**FIELD SAMPLING PLAN ADDENDUM
FOR THE
BACKGROUND GROUNDWATER CHARACTERIZATION AT MODERN LANDFILL
PREPARED IN SUPPORT OF THE REMEDIAL INVESTIGATION
NIAGARA FALLS STORAGE SITE

NIAGARA COUNTY, NEW YORK**

Contract DACW-49-97-D-0001
Delivery Order 0012

RESPONSE TO COMMENTS

Figure 2
Decision Tree
Background Groundwater Sample Collection

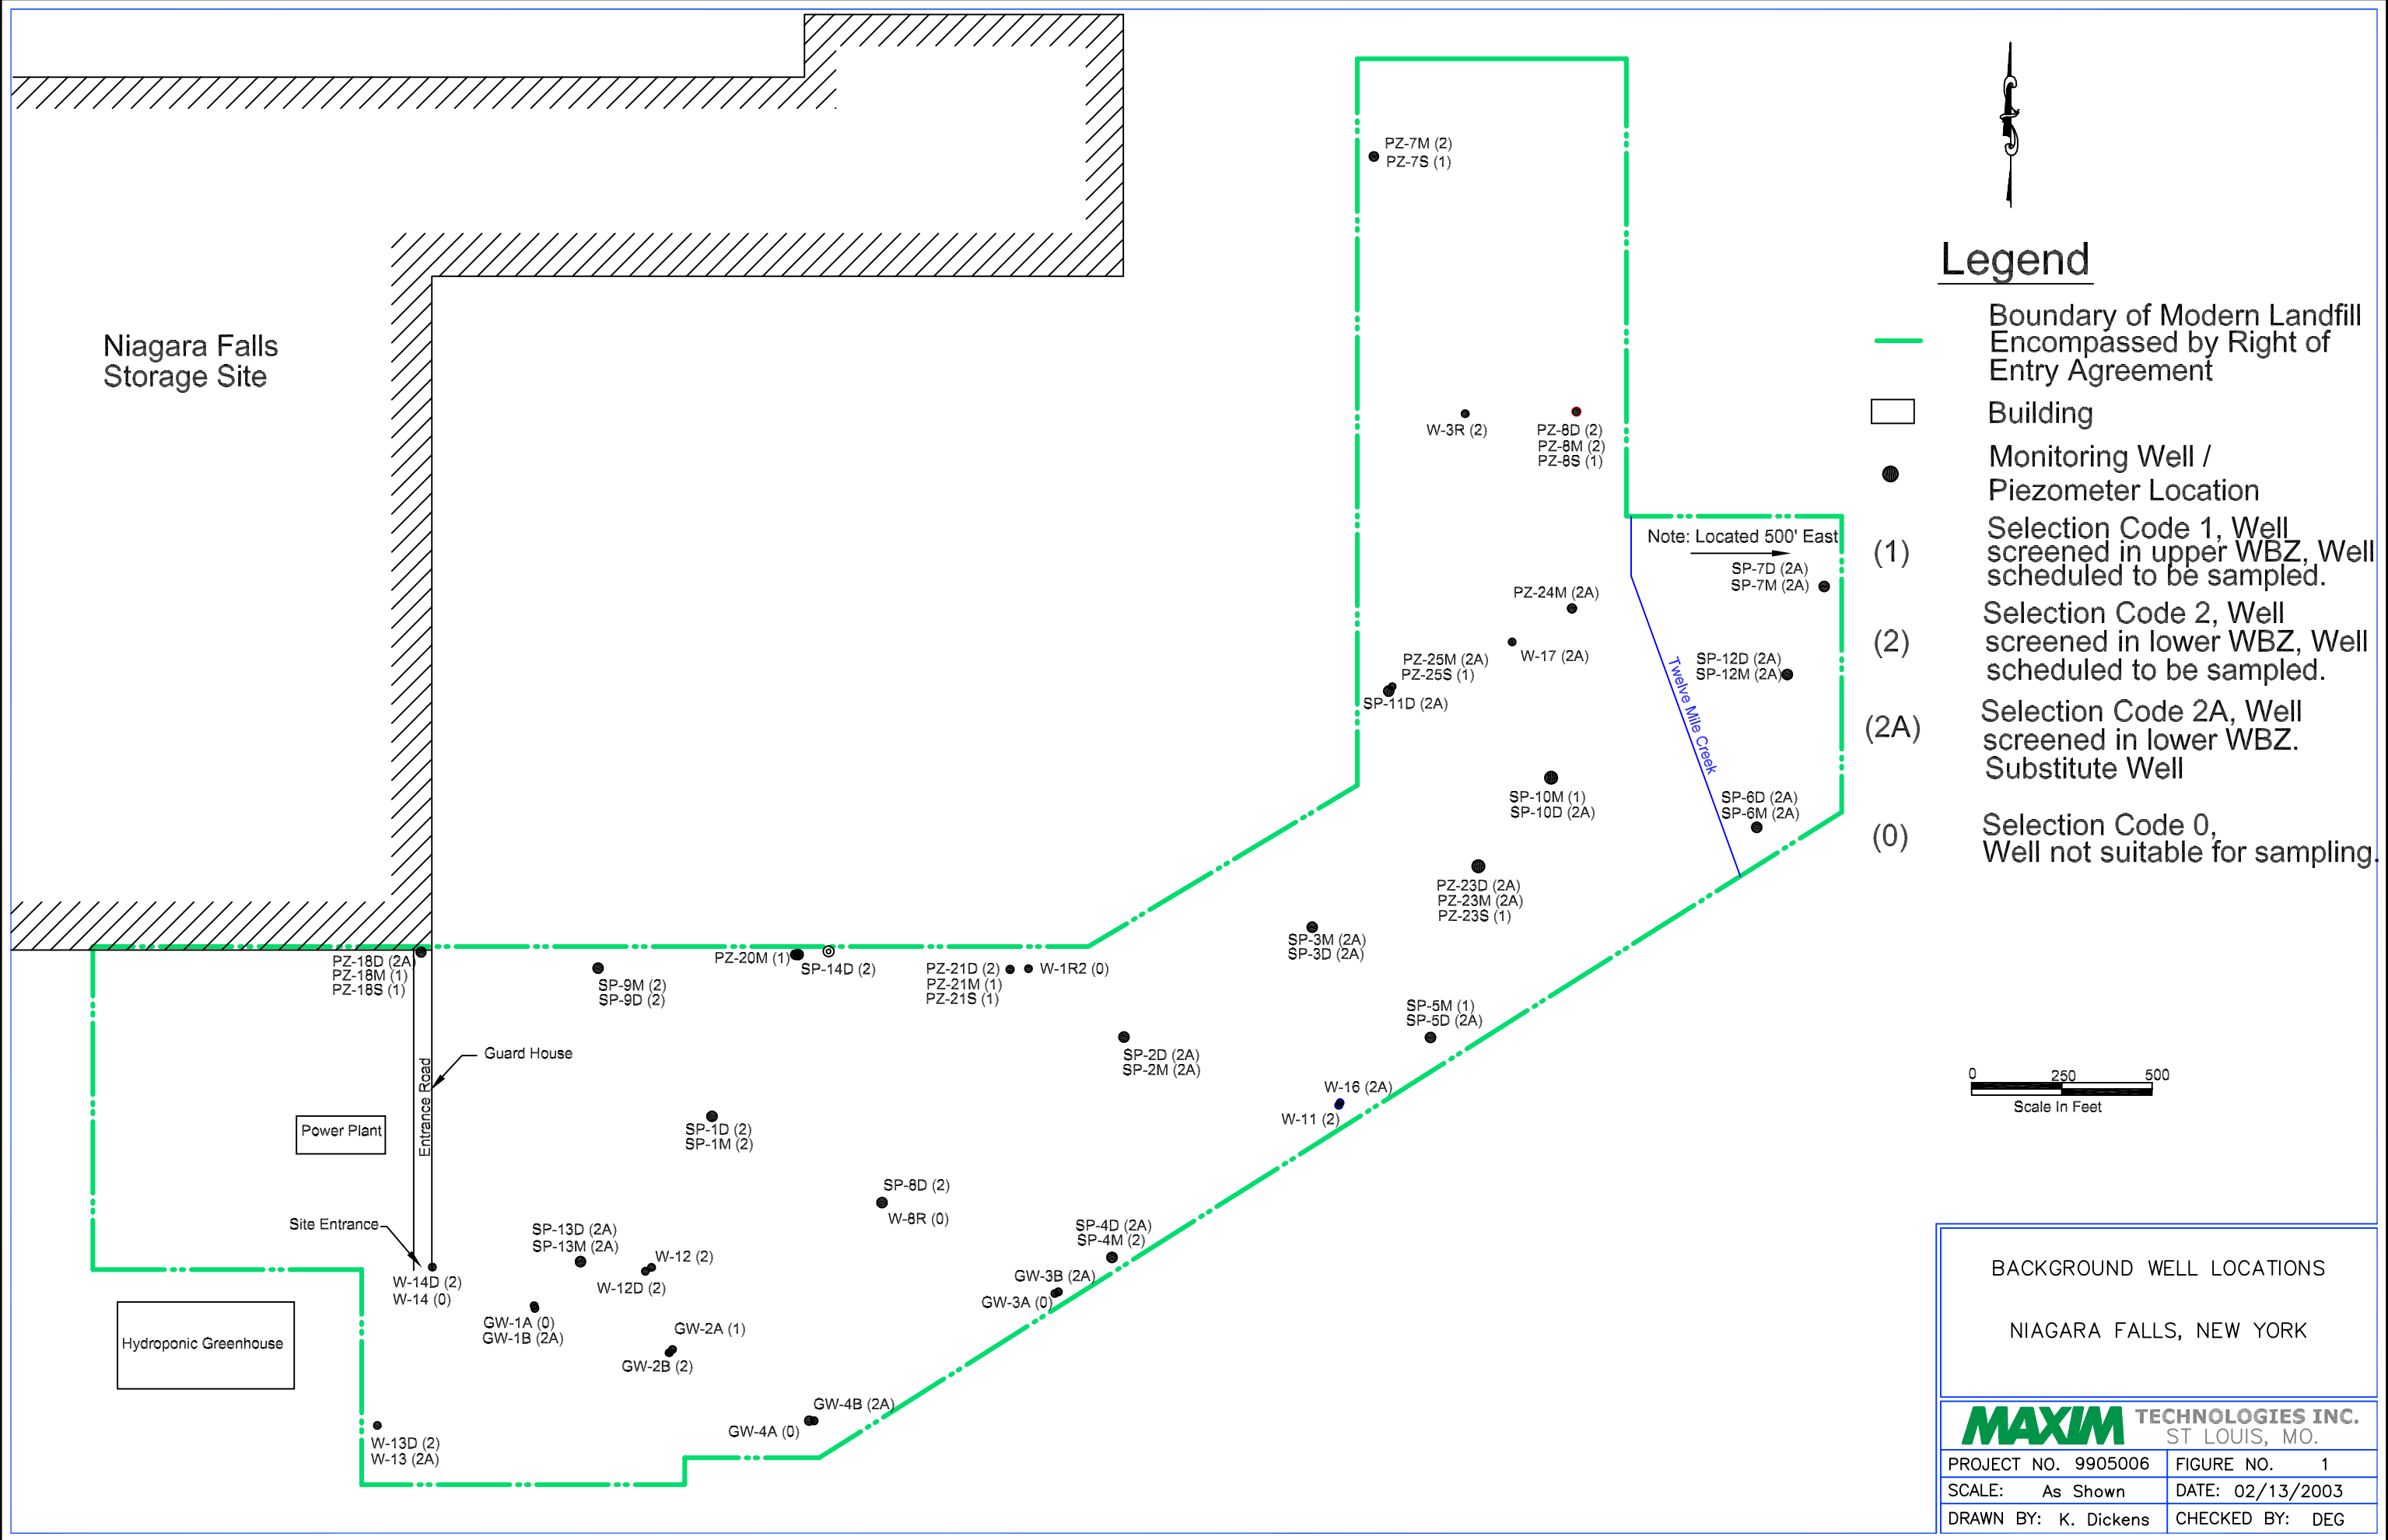
Comment 7: Section 5.0 – Step 4, the end point of 5 hours before any action is sought is not acceptable. The low-flow procedures are designed to achieve stabilization within 15 – 30 minutes at most. Some difficult wells may take up to an hour, however, at that point other problem sources must be investigated such as instrument problems, incorrect placement of pump within well screen, and improperly screened well. Contingency plans should be developed and incorporated into the decision tree (Figure 2).

Table 1
Modern Landfill Wells

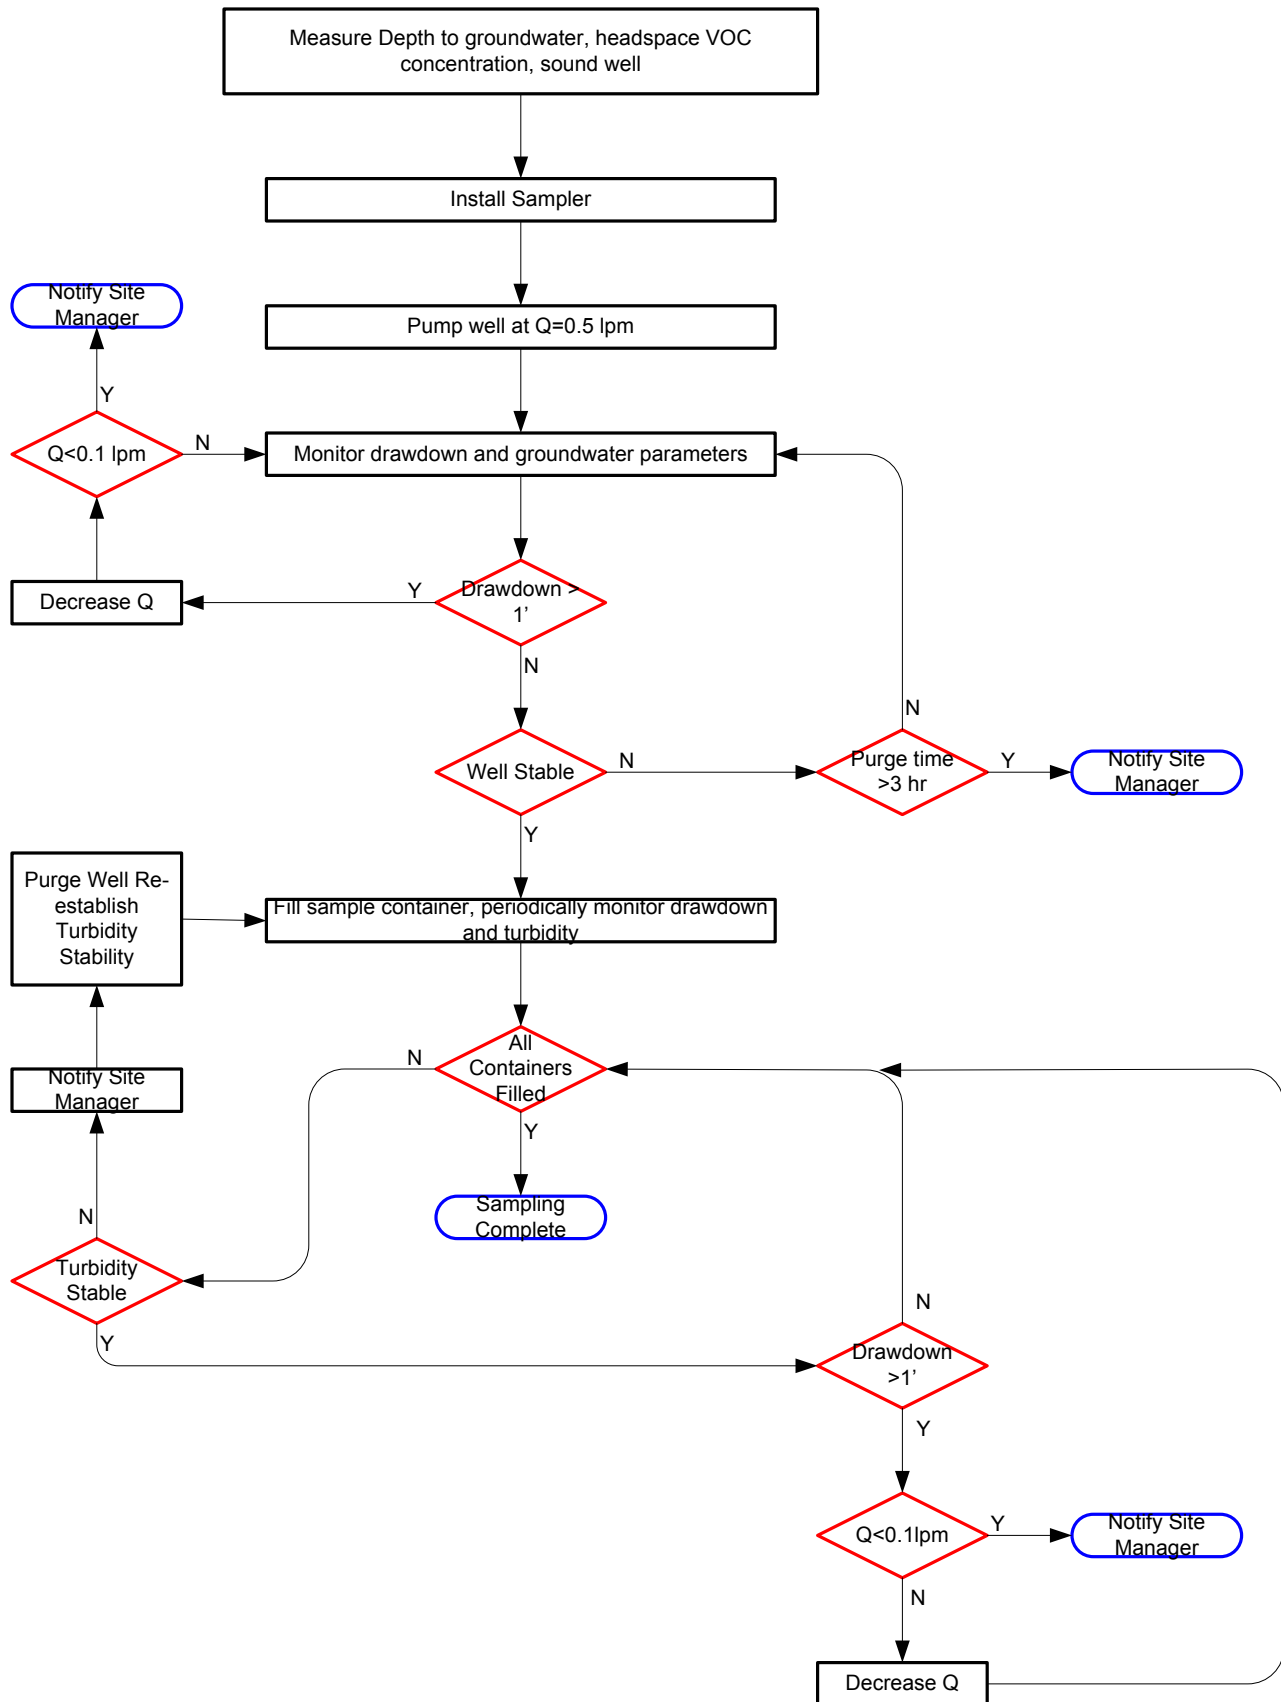
Comment 9: Page 7: Couldn't find the substitute wells on Table 1.

Comment 4: Table 1. Well SP-12M lists a screened unit as SL, yet that definition does not appear anywhere.

Comment 5: Table 1. While all wells within selection code 2 provide good aerial distribution across the site, sample data from wells in the Queenston formation should be used separate from the data collected from the 2 wells in the sand silt outwash unit and the well from the basal red till. This would address your (Michelle Rhodes') initial comment number 10 concerning geochemical differences between the sand and silt outwash and the weathered upper Queenston. Additionally, the potentiometric surface map generated by focusing on the water level data from the Queenston formation only may be of greater relevance in determining true groundwater conditions and characteristics.

Response 9: The footnote defining substitute wells has been clarified.

Response 4: The table has been revised. The information originally supplied to Maxim described the lithology of the screened unit of SP-12M as SL ('sand lens'). This classification has since been clarified and the table has been revised accordingly. It is now reported as Sand Silt Outwash and Basal Red Till.

Response 5: As part of the preparation of the comparative memo, the analytical results for the Queenston formation will be compared to the results for the Sand and Silt Outwash Unit to determine if the analytical results for these two units are statistically different. The USACE groundwater contractor HydroGeoLogic, Inc will perform further evaluation of the degree to which these two units are hydraulically connected.

Figure 1:

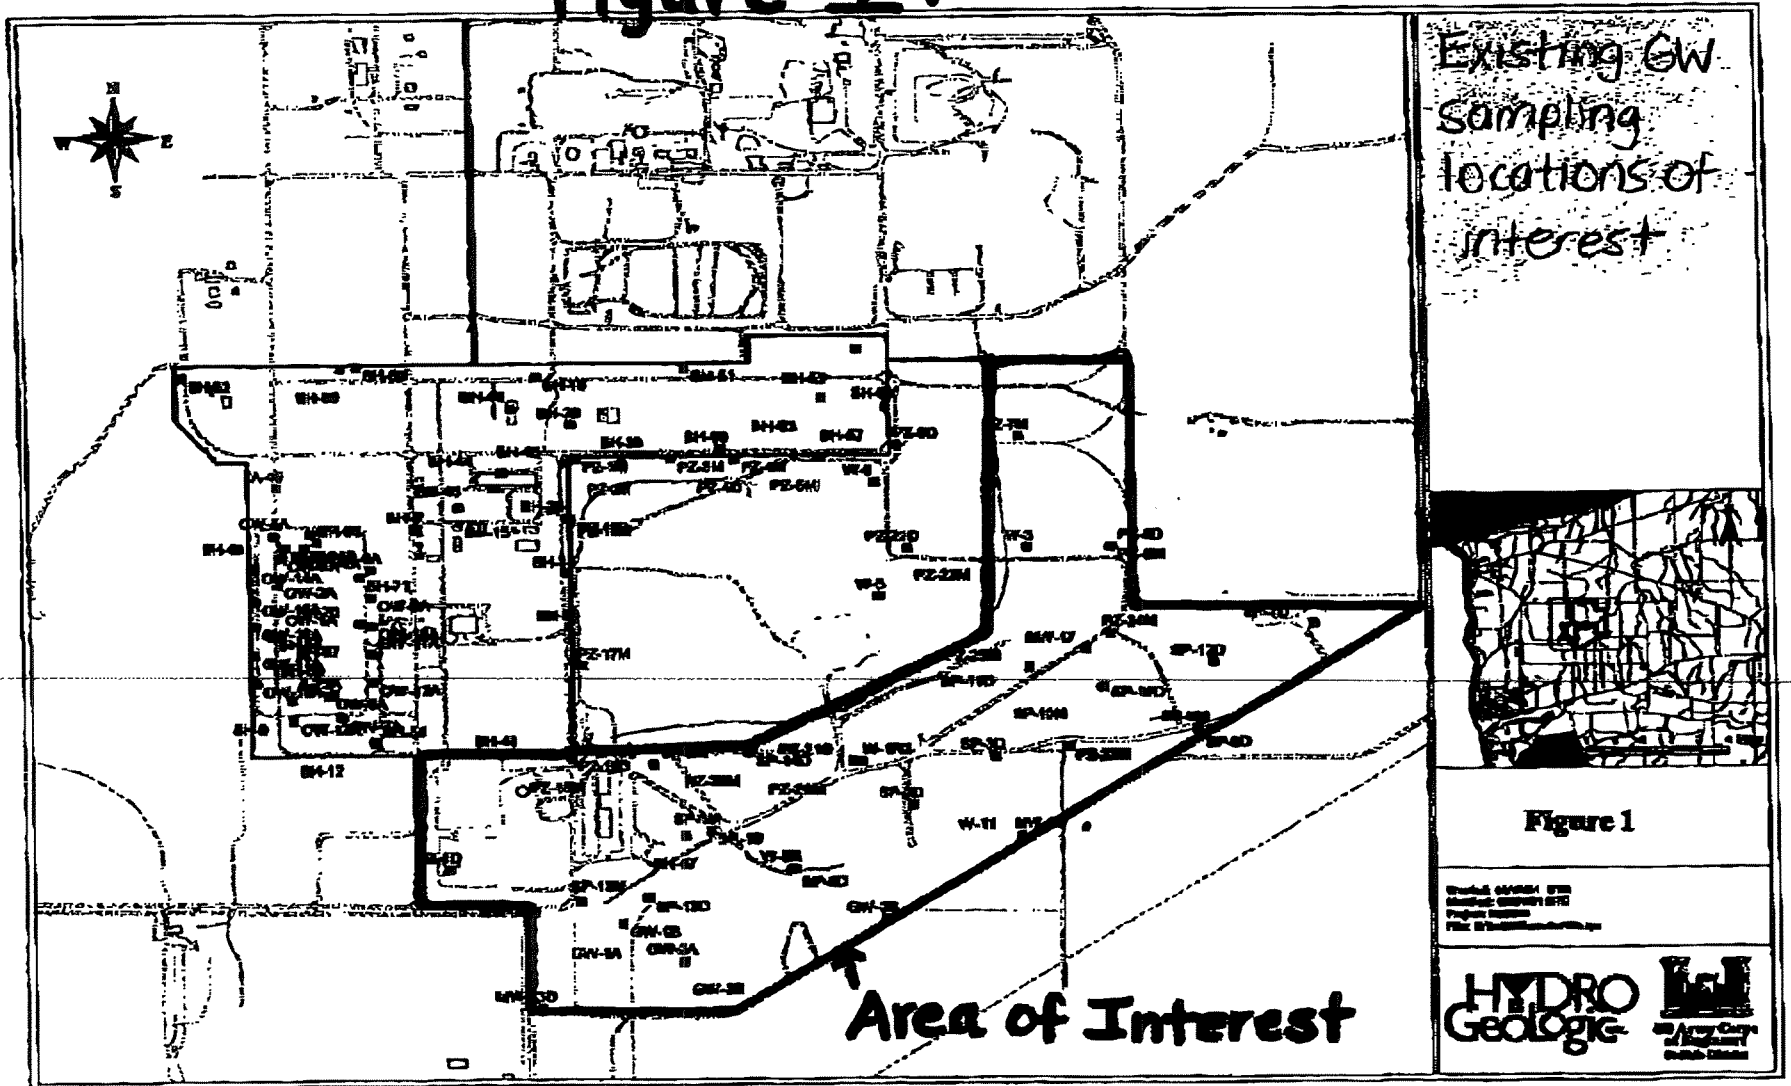
Comment 7: p. 4, section 3.0, last paragraph: edit: "...Right-of-Entry Agreement are listed in Table 1 and shown on Figure 1." then delete text not needed.
